TRAFFIC SIGNAL STRAIN POLE AND PEDESTRIAN PEDESTAL CHART									
POLE NO.	FOUNDATION ELEVATION (FT)	POLE TYPE	DESIGN NUMBER	POLE HEIGHT (FT)	ATTACHMENT HEIGHT (FT)	INDEX ANGLE (DEG)	ANGLES (DEG) FROM INDEX LINE		
							POWER SERVICE	PEDESTRIAN SIGNAL HEAD	PEDESTRIAN PUSH BUTTON
								CABLE ENTRANCE (TOP)	POLE MOUNTED SIGN
SP-1	575.17	TC-81.10	12	27'	26	126			
SP-2	570.17	TC-81.10	12	32'	31	182			
SP-3	567.22	TC-81.10	12	32'	225	277			
SP-4	566.28	TC-81.10	12	33'	32.5	180			
PS-3	567.00	TC-83.20		8'					
PS-4	566.03	TC-83.20		8'

ADDENDUM	
△ ADDENDUM 1 - ISSUED 12/17/19	TC-84.20 10/18/13
△ ADDENDUM 2 - ISSUED 12/31/19	TC-84.21 10/18/13
△ ADDENDUM 3 - ISSUED 01/17/20	TC-85.10 01/18/19
△ ADDENDUM 4 - ISSUED 04/27/21	TC-85.21 01/20/17

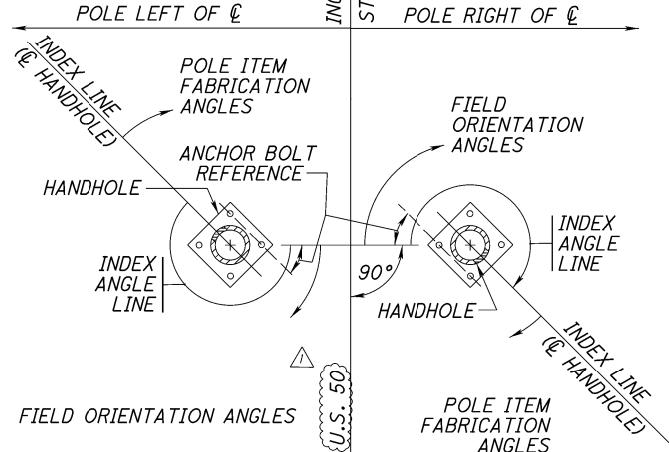
△ DUE TO UTILITY CONFLICTS, SP-4 WAS RELOCATED 6.5' EAST OF THE ORIGINAL POLE APPROVED LOCATION. THE SAG ON THE SPANS FROM SP-4 NEED TO BE REDUCED TO OBTAIN THE PROPER CLEARANCE FOR THE SIGNALS ON THOSE SPANS FROM SP-4.
